EQUIPMENT UPDATE

Log Number: EU-8-375

Part: CORNER DOOR SWITCH BRACKET

Models Affected: C

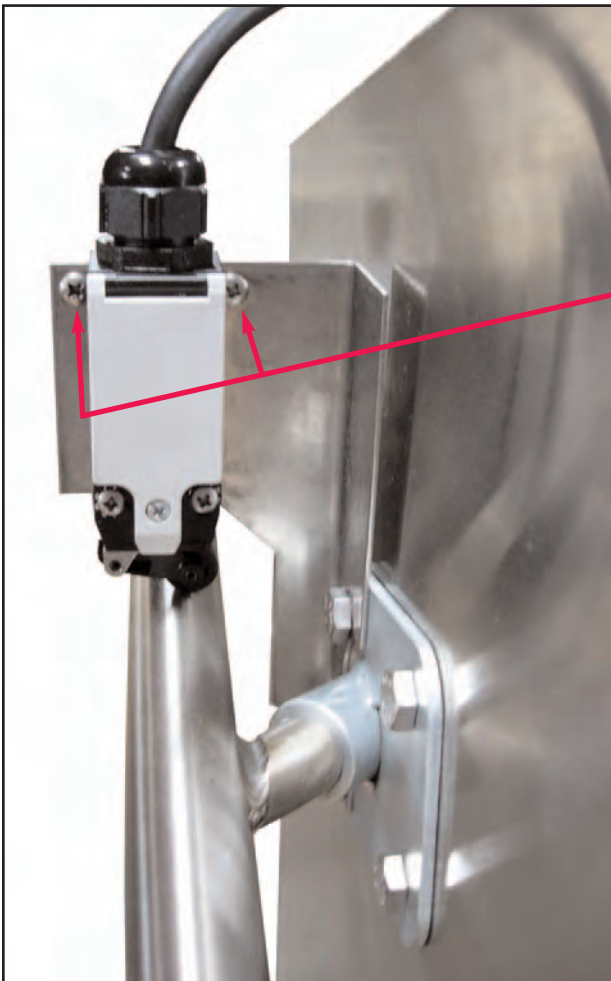
Field reports indicate the door safety switch has the potential of coming loose, causing machine malfunctions. CMA has received positive field response to the design change of securing the door safety switch on models AH and B.

The head of the screw prevents the switch from coming out of alignment or moving. Future machines will have this feature added.
